Figure 2.1e
Infrastructure Design Review
- Turbine 05

Engineering

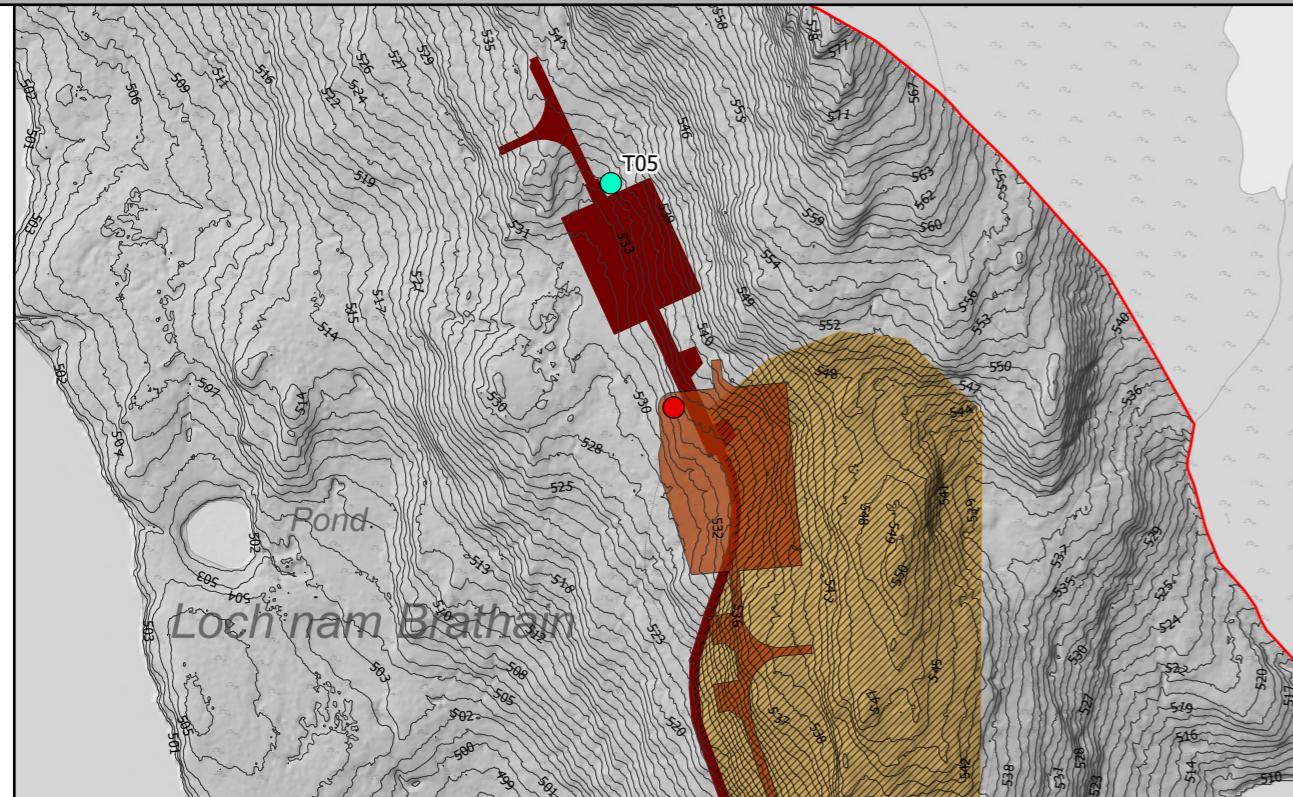
T05: Reason for Moving: The location has been moved to minimize the impact on areas of deeper peat introduced by the larger hardstand required for the turbines. The new location is in areas of shallow peat. This turbine location was selected following a Landscape and Visual assessment by consultant (ASH). This position has a lower impact to that of the original position that was proposed.

Engineering: The new arrangement reduces the length of the access track significantly. The Turning Head has been moved to adjacent the proposed crane pads, further reducing disturbance. The new position avoids the steepest slopes adjacent to the East of the Consented location.

Geology

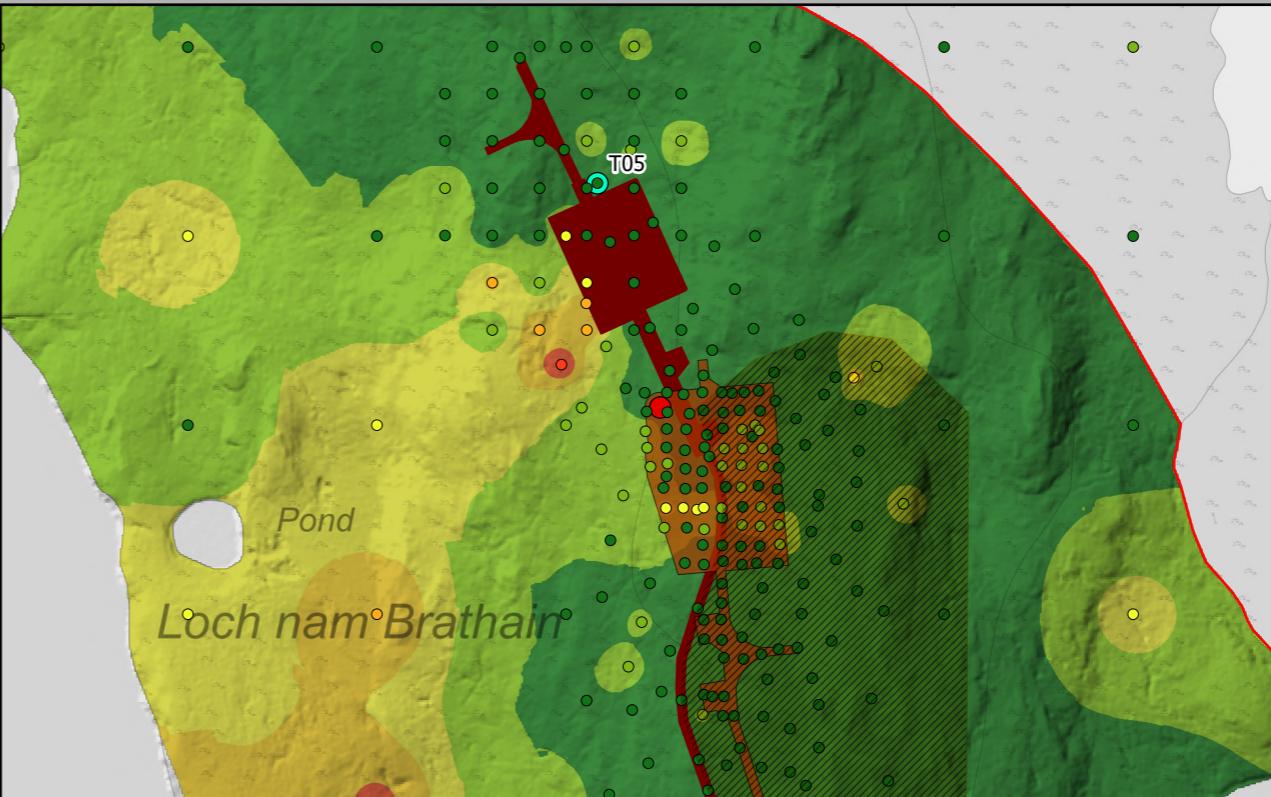
Geology Impacts: The larger hardstand would have required building on the deep peat area to the west. By moving the turbine south, the infrastructure can be built in areas of mainly shallow peat. The move of the hardstand to the south, locates most of the infrastructure out of peat compartment "9". The proposed infrastructure is within the current consented 50m micrositing buffer.

Ecology

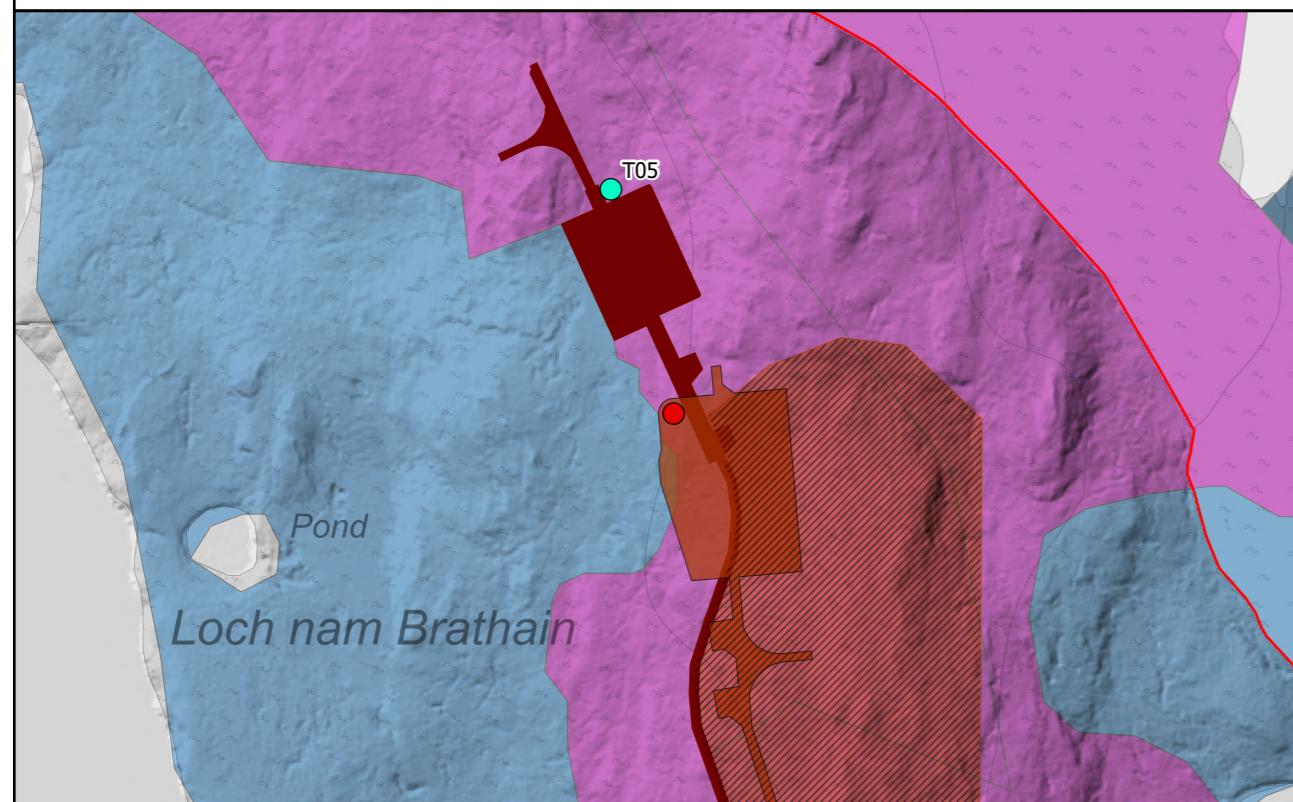
Ecology Impacts: The consented turbine location with the required hardstand is partially within M17b, M17/M17a/M18a/M19a. The proposed revised turbine location and hardstand reduces the amount of infringement on this habitat and the majority of the proposed infrastructure is now in Wet heath (M15c) and some Blanket Mire (M17/M17a/M18a/M19a).

Hydrology

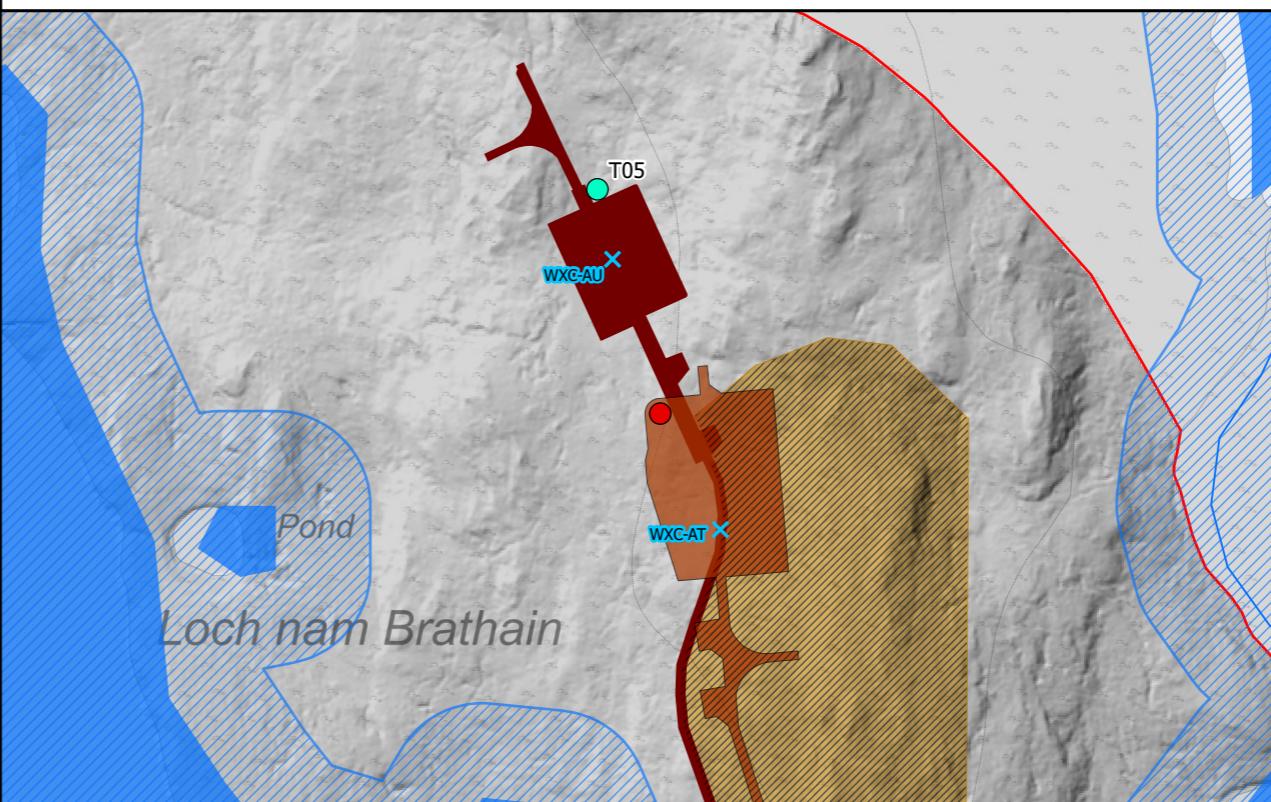
Hydrology Impacts: The proposed location is outside the 50m water buffers. One less water crossing required.
